To: McNeilus Refuse Product Owner
Re: VSR-TSB-044 – Zero Radius Arm Hook Latch Component Change
NHTSA Recall #24V-632
Certain 2015 to 2024 model year Zero Radius vehicles

Inspection required before ordering parts

Figure 3

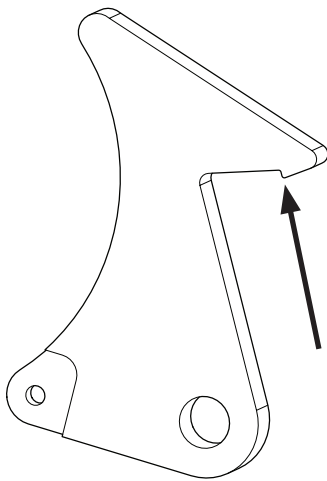
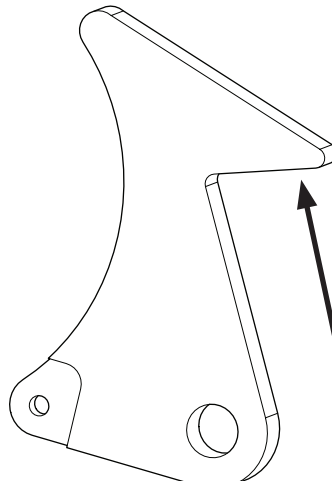
On trucks that lack the notch on the arm hook latch, the arm hook may walk itself out of the pocket, allowing for the arm to start to creep away from the truck body. This is especially true if the operator has neglected to manually latch the secondary arm transit latch chain. The updated arm hook latch component (PN 1675151) includes the notch.

- If the notch on the arm hook latch component is present (Figure 3), then no changes are necessary to the component. Verify software version is 0.9.7.16 or later. If it is, then no action is required for software updating. See the verification procedures on page 7.
- Otherwise, the latest Production software must be installed by a McNeilus-authorized technician and you **must call the McNeilus service network at 1-888-686-7278 to make an appointment with your authorized dealer.**
- If the notch on the arm hook latch component is absent (Figure 4), then continue the procedure to **install the updated arm hook latch with notch** and order the updated arm hook latch component (PN 1675151) and the hardware.
- Before ordering parts, make sure you followed the instructions to inspect the wear items as well (see the instructions on page 3 under the IMPORTANT section).

Install the updated arm hook latch with notch component

Figure 5

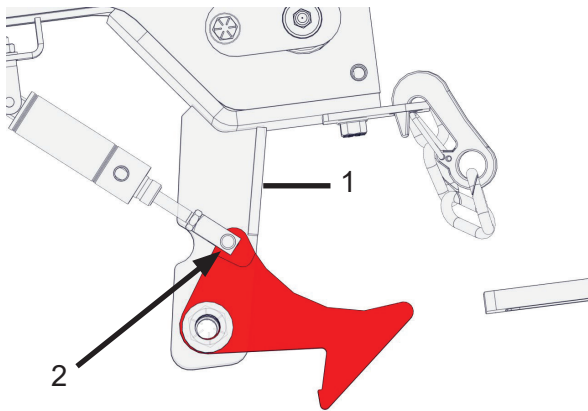
1. Follow the Preparation Procedures on page 4.
2. Use wrenches to remove the hardware securing the existing arm hook latch to the latch mounting bracket (Figure 5, Item 1 shows the latch mounting bracket). Retain the washers (quantity 6).
3. Use a pliers to remove cotter pin out of cylinder pin (which is holding the latch component to the cylinder) (Figure 5, Item 2 shows the cylinder pin and cotter pin locations). Retain the cylinder pin for reinstallation. Discard the cotter pin, the hook latch component, and its bolt and nut.
4. Install the existing cylinder pin into both the cylinder clevis and the new arm hook latch component.
5. Install the new cotter pin into the cylinder pin.

Figure 6

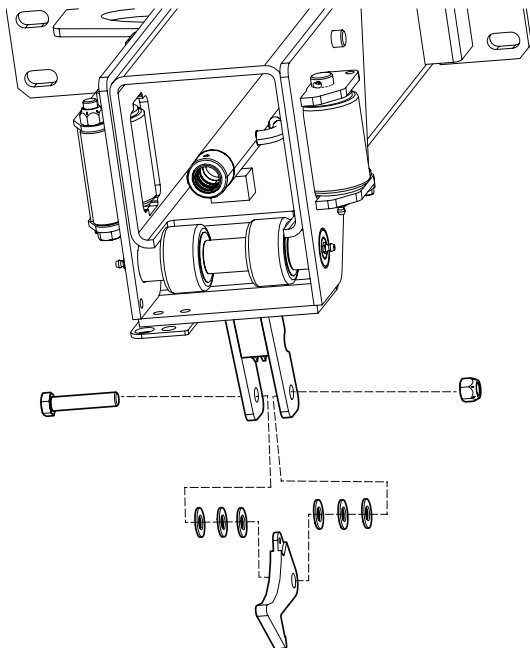
6. Install the new bolt and the existing washers to secure the arm hook latch component to the latch mounting bracket. (Figure 6).
7. Add the new nut and tighten nut until it makes contact with the arm hook latch component, but do not overtighten.

Figure 7

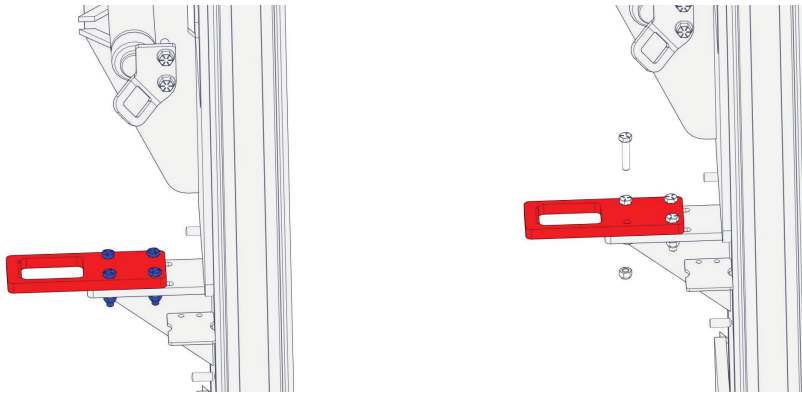
7. Check if there is a 1/4 inch gap between the receiving plate and the arm hook latch.
8. If adjustment is required to achieve a 1/4 inch gap between the receiving plate and the arm hook latch, loosen the hardware on the latch receiving plate and move the plate within the slots until the 1/4 inch gap is achieved. Tighten and torque the hardware to 15 ft.-lbs. to secure.
